Planning Report

Ballantrae Woods

Agenda Item	3
Case Number	15-004Z/PDP/PP
Proposal	A residential development comprising of 45 single-family lots and 90 detached condominiums on approximately 49.6 acres
Request	Review and recommendation to City Council of a <u>rezoning with preliminary development plan</u> under the Planned District provisions of Zoning Code Section 153.050, and a <u>preliminary plat</u> under the provisions of the Subdivision Regulations, Chapter 152.
Site Location	Northeast corner of Rings Road and Cosgray Road intersection, east of railroad tracks
Owner/Applicant	Schottenstein Homes, represented by Jack Reynolds and Paul Coppel
Case Manager	Devayani Puranik, Planner II (614) 410-4662 dpuranik@dublin.oh.us
Planning Recommendation	Disapproval of the rezoning with preliminary development plan; and Approval of the preliminary plat with 1 condition

Proposal

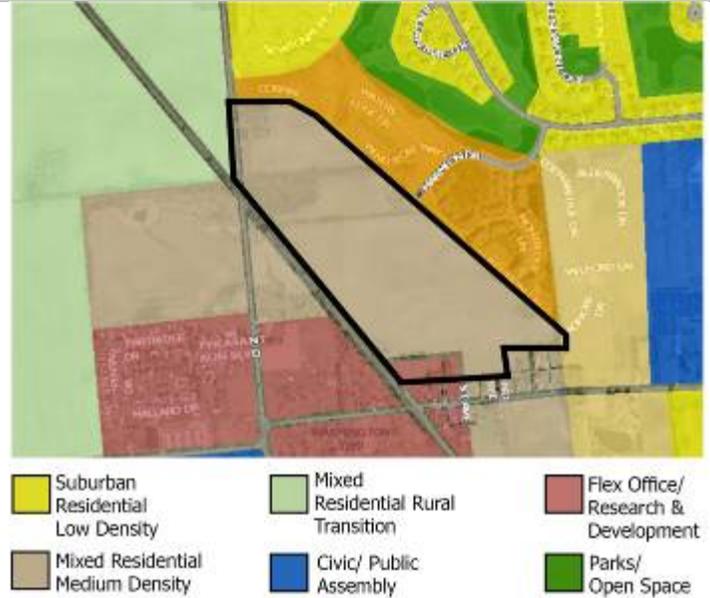
Based on Planning's analysis, the rezoning with preliminary development plan proposal fails to meet all the rezoning/preliminary development plan criteria and disapproval is recommended.

A 100-foot setback is required along Churchman Road. Lots 1 and 3 are shown at a 45-foot setback from Churchman Road on the preliminary plat and the development text addresses this decrease in the Churchman Road Open Space section. The setback deviations for all lots should be clarified in the development text in the appropriate section for each Subarea.

The layout shows two, fee simple single family lots (#44 and #45) south of Ballantrae Woods Drive next to the detached condominiums. Planning recommends that these two lots be detached condominiums to keep the consistent setback and streetscape from the main entry point to the development.

The proposed standard for the garage door opening for front facades is a maximum of 45% for a two-car garage and a maximum of 50% for a three-car garage. The Appearance Standards of the Zoning Code limit the percentage of the home frontage for garage door openings of more than 18 feet to 36 feet to 45%. Planning recommends the garage door openings meet the Appearance Standards.

The site plan also shows the parallel parking spaces for the visitor parking within Subarea B at the ratio of 1 per 4 units. These spaces do not appear to be in convenient, useable locations. In addition, head-in parking should be the preferred parking arrangement, especially along the narrower sections of private drives. The applicant should continue to work with the Staff to finalize the design and locations for additional visitor parking spaces.

- 1) That the proximity to active railroad tracks is clearly stated in writing during the sales process and the options to install windows and exterior walls with higher STC levels for sound abatement are explored prior to the final development plan.

- 10) That the two fee simple single family lots (#44 and #45) south of Ballantrae Woods Drive adjacent to the detached condominiums are replaced with the detached condominiums for consistent setback and streetscape at the main entry point to the development.

- 13) That the three-car garage percentage in Subarea A is limited to 45% per the Appearance Standards as opposed to 50% per the development text.
- 14) That the applicant work with the Staff to finalize the construction plans, right-of-way dedication, and responsibilities for Phase 2 and 3 of the Churchman Road project.
